Access Compliance Report Public Rights-of-Way (Curb Ramps)

Main Street: BASKERVILLE_RD		Cross Street: KERTH_DR		Location:	S
ADA ID: RPRK211215122824	Ramp Type:Type 1 - Perpendicular	Initial Pass/Fail: Pass	Overall Compliance: No	Severity Score:	16
Codes/Mitigation Info/Possible Solution			Field Measurements/Component Compliance

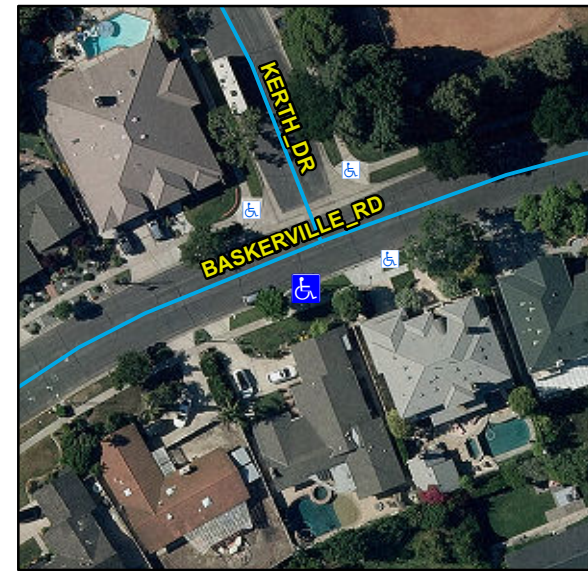
Remove & Replace Entire Ramp. Remove & Replace Gutter.

R304.2.2, R305, R304.5.4, STD 1115
